Re: Addendum No. 1 to the Bidding Documents for Chiller Replacement – Bureau of Motor Vehicles

MECHANICAL PART PLAN  
STATE OF MAINE BUREAU OF MOTOR VEHICLES  
CHILLER REPLACEMENT  
101 Hospital Street, Augusta, ME 04301  
Date: 12-22-2020  
Drawn By: CRG  
Checked By: ASD  
Project Mgr: ASD  
Project No: 20051  
Card File:  
Graphic Scale: 0" to 1"

**MH-100**  
ISSUED FOR BID

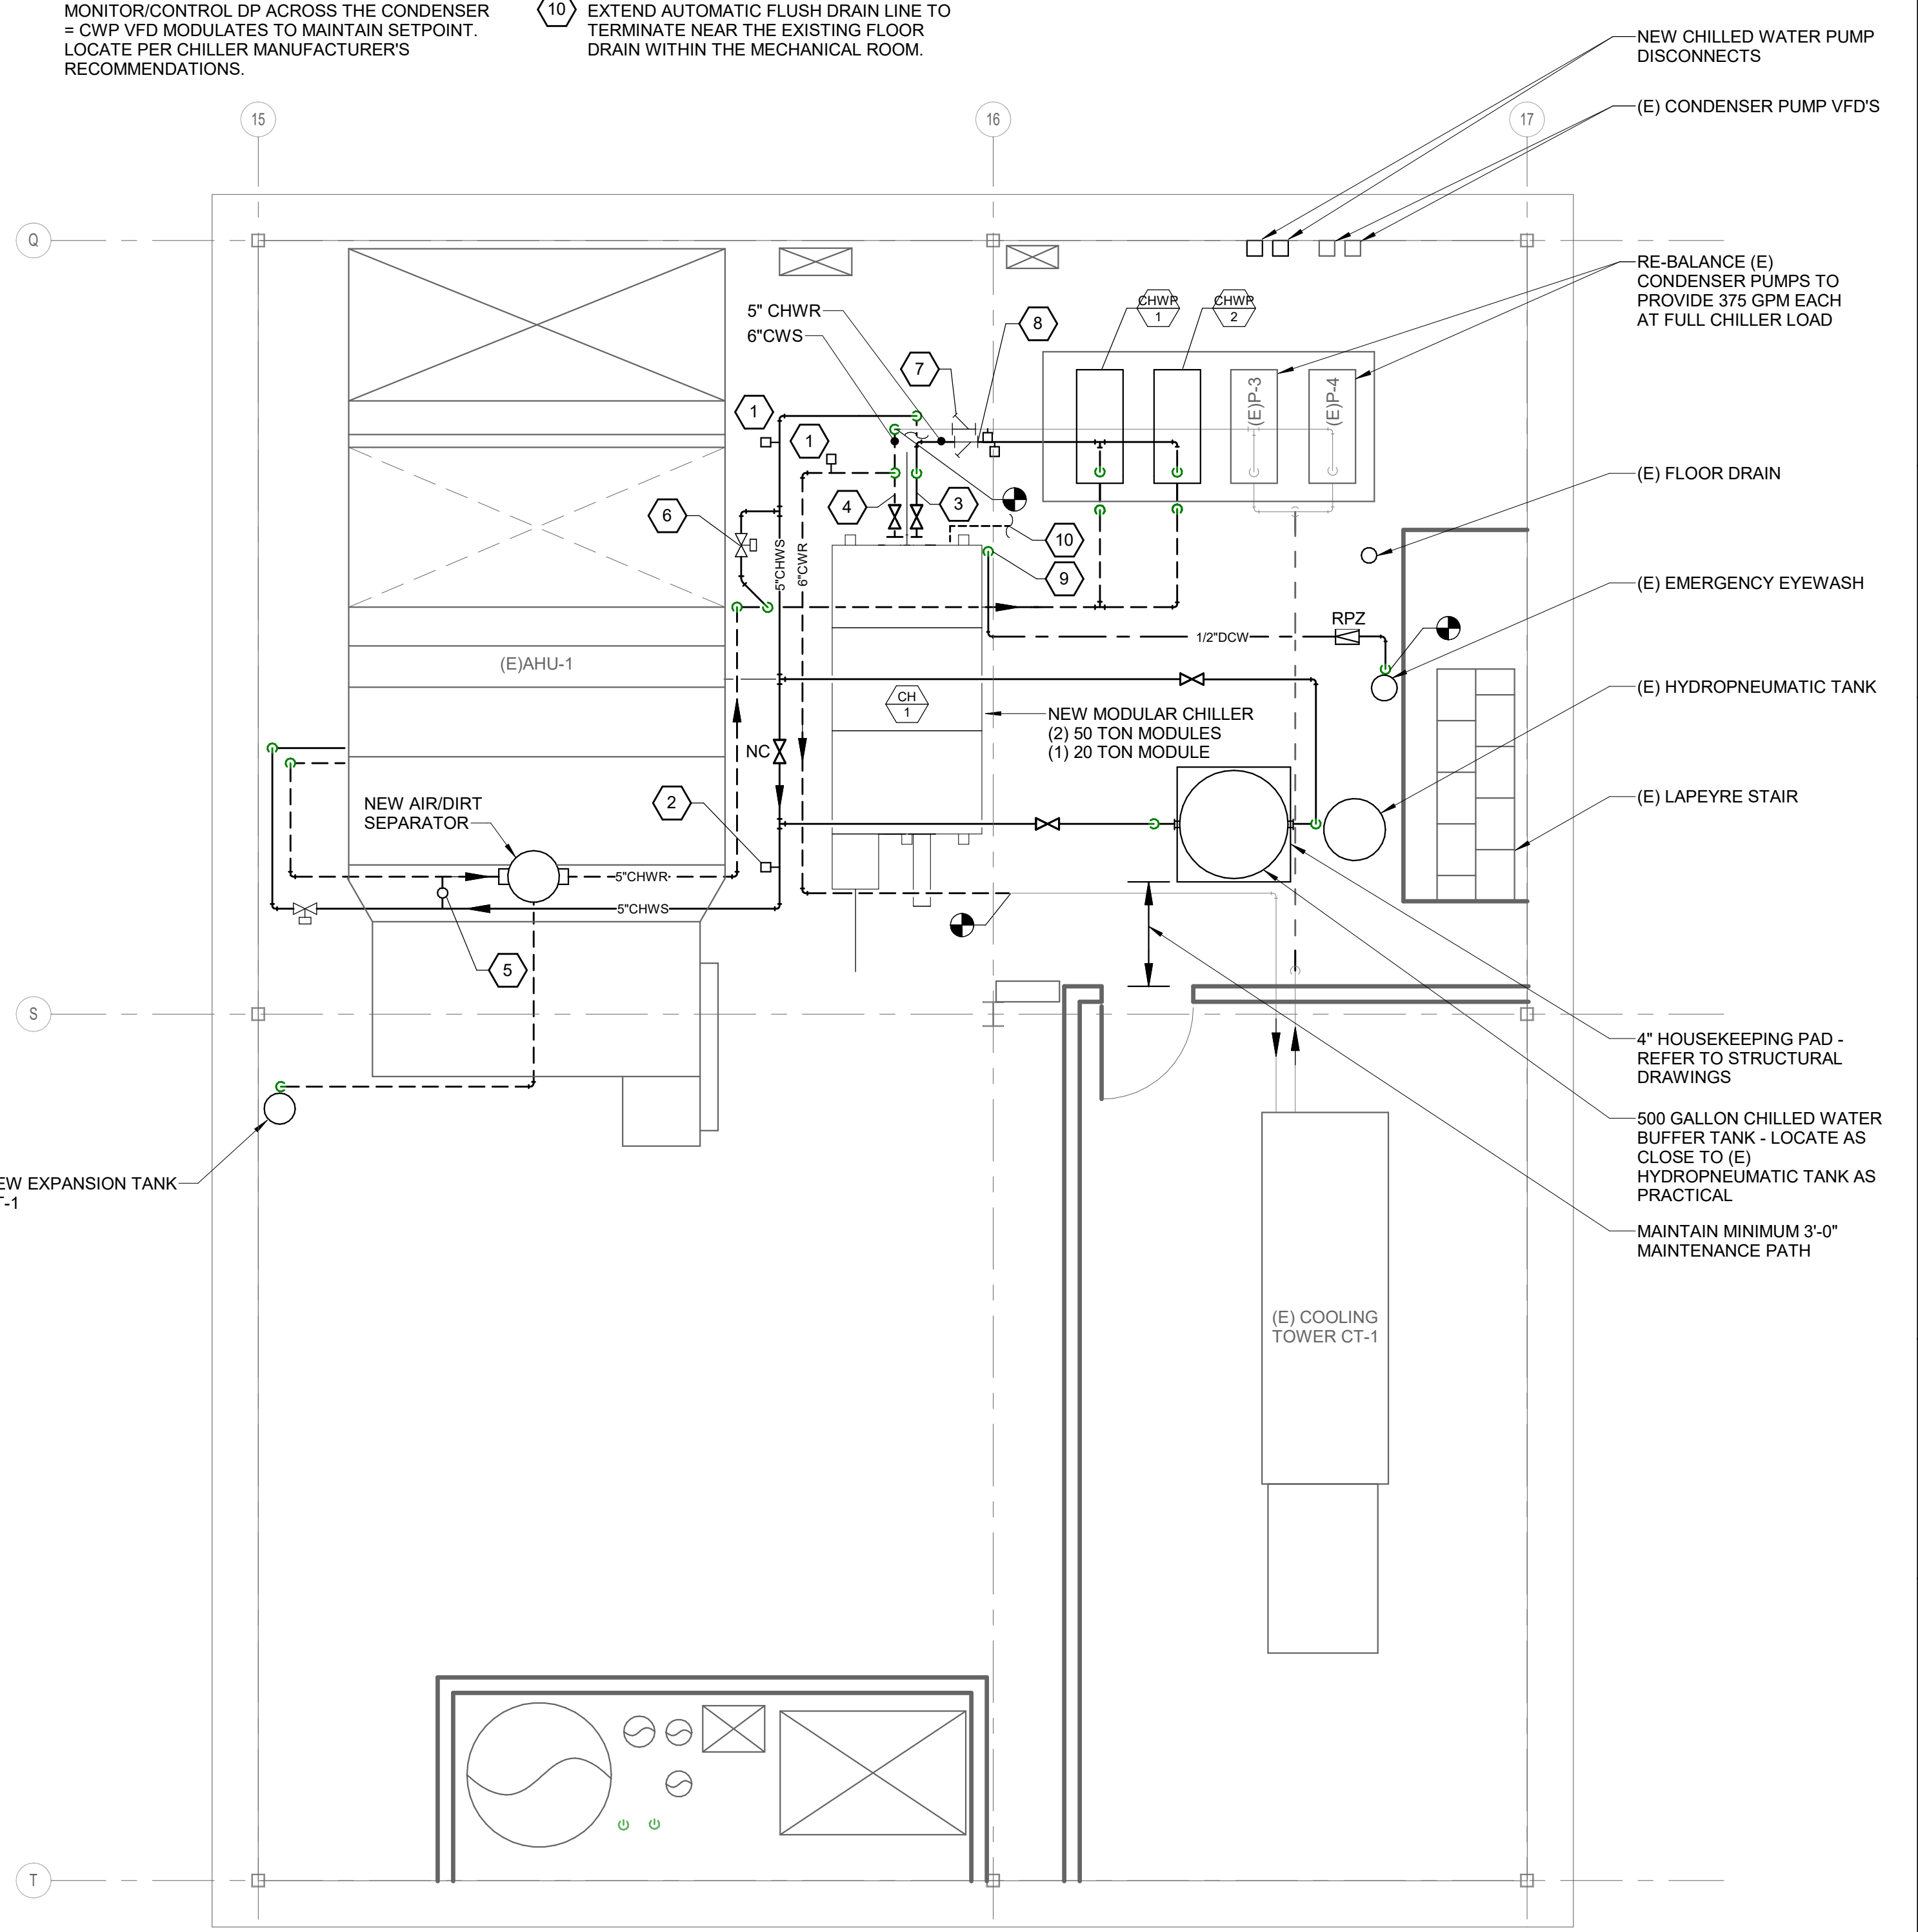
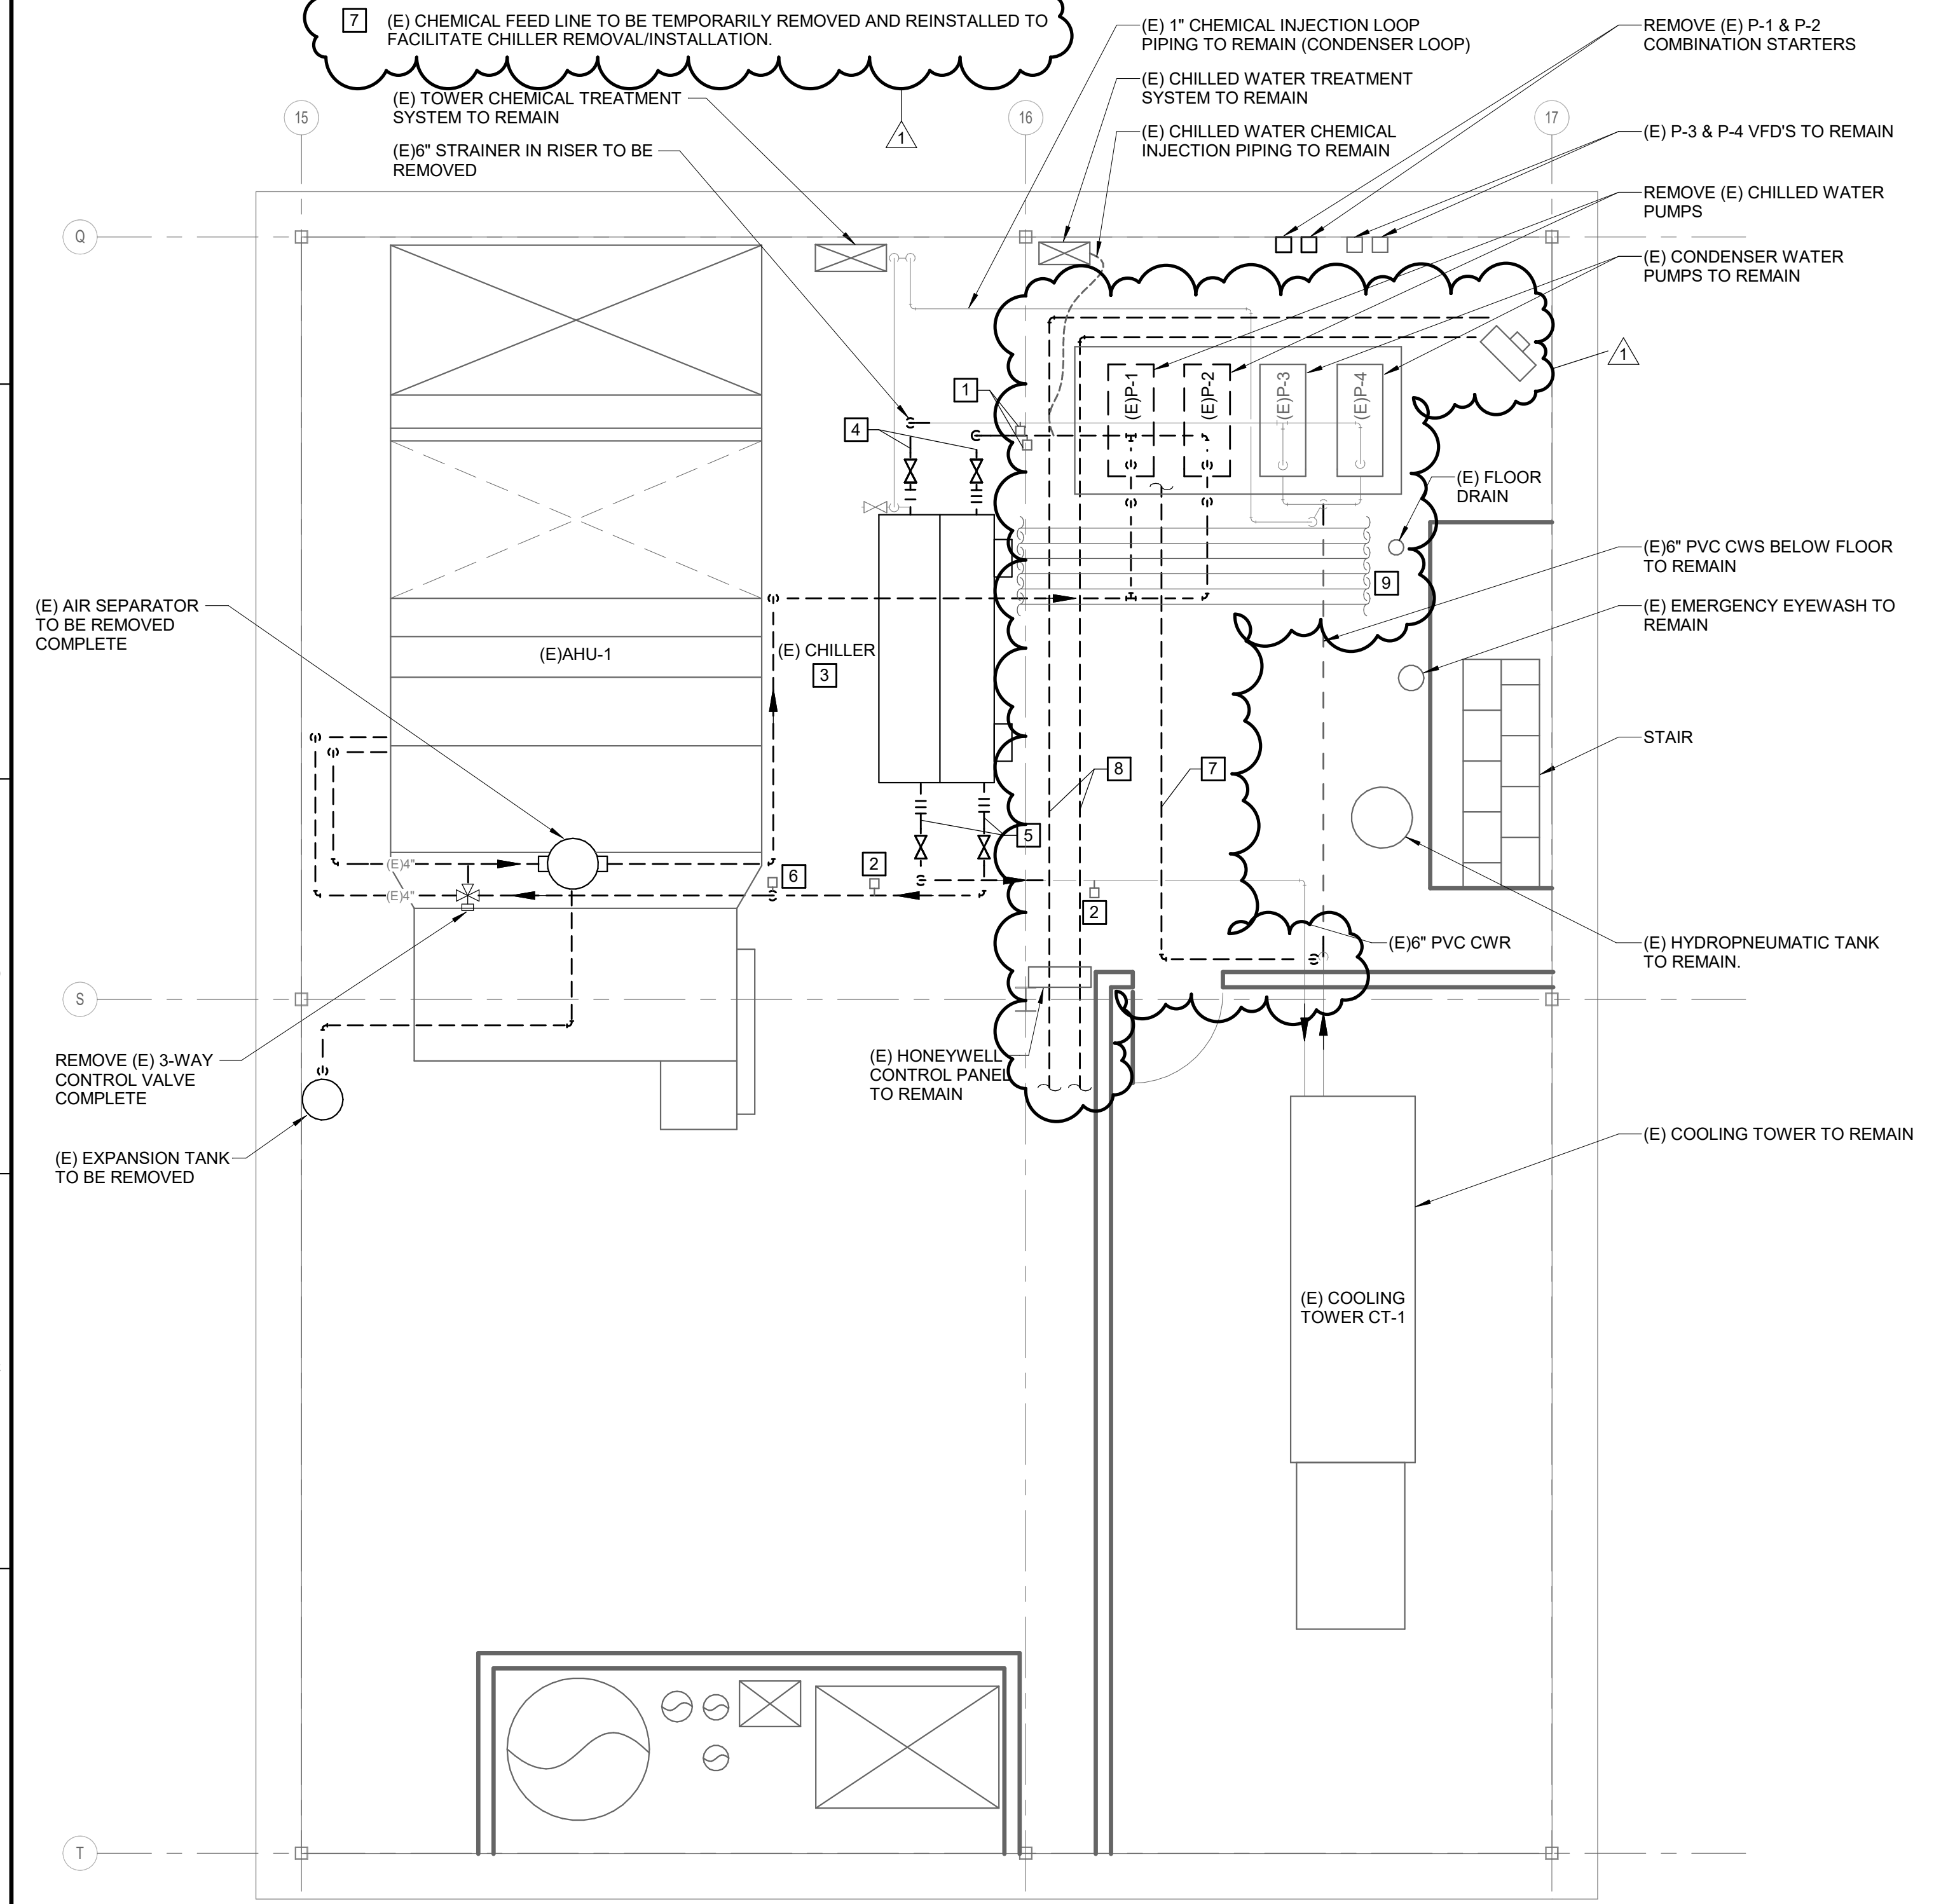
- C. Item discussed during the project walk-through:
  1. There are hot water supply and return pipes that serve a unit heater running below the area for the proposed roof hatch, as well as a 1'2" chemical feed line for the condenser loop. These will need to be relocated to facilitate the installation of the equipment.

2. There are many electrical conduits running across the penthouse below the new roof hatch location, approximately 8'-7" above finish floor and 6'-10" below the roof deck. It is the intent that these conduits stay in place, with a requirement to offset the equipment below the hatch to avoid the conduits as part of the rigging path.

- A. **DELETE** Sheet MH-100 in its entirety. **ADD** in its place, Sheet Mh-100, re-issued with revisions, attached.
